PROJECT REVIEW REPORT

Project ID	1558
Project Name	Agroforestry and forest restoration for ecological connectivity, poverty reduction and biodiversity conservation in Cerro San Gil, Caribbean Guatemala.
Program(s)	VCS
Verification Period	20-July-2016 to 8-July-2021
Project Proponent	Livelihoods Fund
Methodology	AR ACM0003 "Afforestation and reforestation of lands except wetlands, version 02.0."
Sectoral Scope(s)	VCS sectoral scope 14 (Agriculture, Forestry and Other Land Use): Afforestation, Reforestation, and Revegetation
Validation/Verification Body (VVB)	Aenor Internacional S.A.U.
Assessment Criteria	VCS Standard, v4.1
Date of First Issue	January 5, 2022
Date of Final Issue	17 June 2022

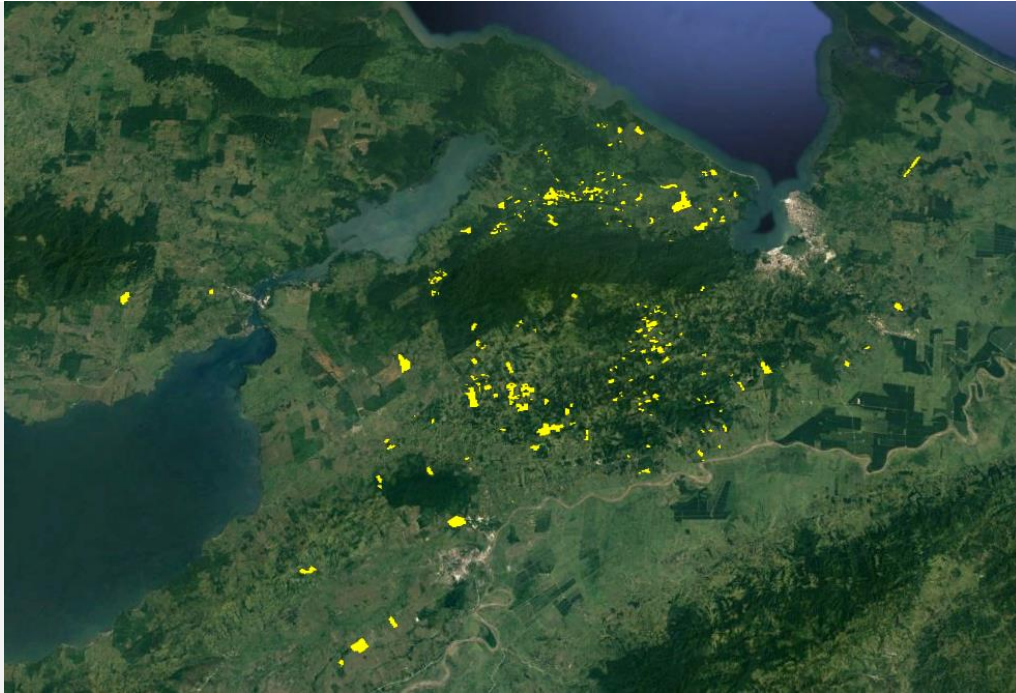
The .kml file that was provided by the PP shows the outermost boundary of the project region but does not indicate the areas of the project (as shown in figure 1 of the monitoring report).

The PP is requested to provide the appropriate .kml file that shows the areas of the project.

A .kml file including project area as shown in figure 1 of the monitoring report has been attached.

The PP has provided the proper KML file that indicates the project areas as shown in figure 1, section 1.7 of the MR. Furthermore, the VVB has approved the updated KML file. The KML file can be seen below:

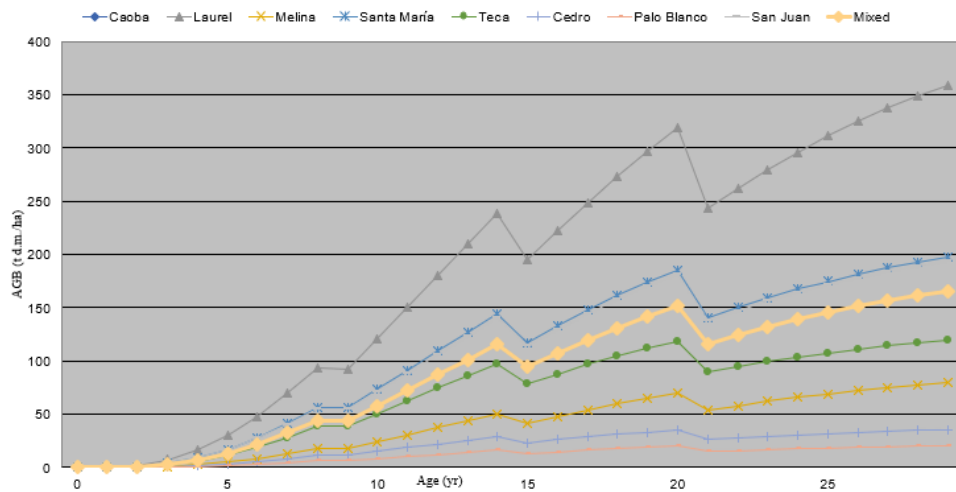
In the worksheet “Forestry” under the spreadsheet that was provided by the PP titled ‘FUNDAECO_Ex-ante 2nd Verification’ displayed a graph that shows the cumulative aboveground biomass against age. The graph shows that the aboveground biomass is decreasing in the years 15 and 21 of the project:

Based on section 3.4 of the PD-MR and the spreadsheet that was provided by the PP, there is an indication of loss of biomass within the crediting period. Therefore, it is necessary for the PP to provide a long-term average, according to sections 3.2.20 and 3.2.21 of the VCS Standard v4.2.

The PP is requested to calculate the long-term average GHG benefit of the project. Furthermore, the project proponent is requested to indicate whether the ERR of the current monitoring period is above/below the long-term average and describe how the amount of the VCUs that is going to be issued are in accordance with the 3.2.20 and 3.2.21 of the VCS Standard v4.1. Finally, the VVB is requested to provide an assessment of this matter.

Forest plantation system is the only one where thinning is planned. Thus, the long-term average has been calculated by the PP as per sections 3.2.20 and 3.2.21 of the VCS Standard v4.1 only for this plantation systems areas within project area. All calculation procedures has been included in the Annex of Monitoring Report and an excel spreadsheet ("FUNDAECO_Long_Term_Average_2022_04_04_MR.xlsx") describing all calculates is provided to the VVB and Verra.

AENOR, after checking the MR and the excel spreadsheet, deems correct the calculation of the long term average for the forest plantation system that is the one that has thinning planned.
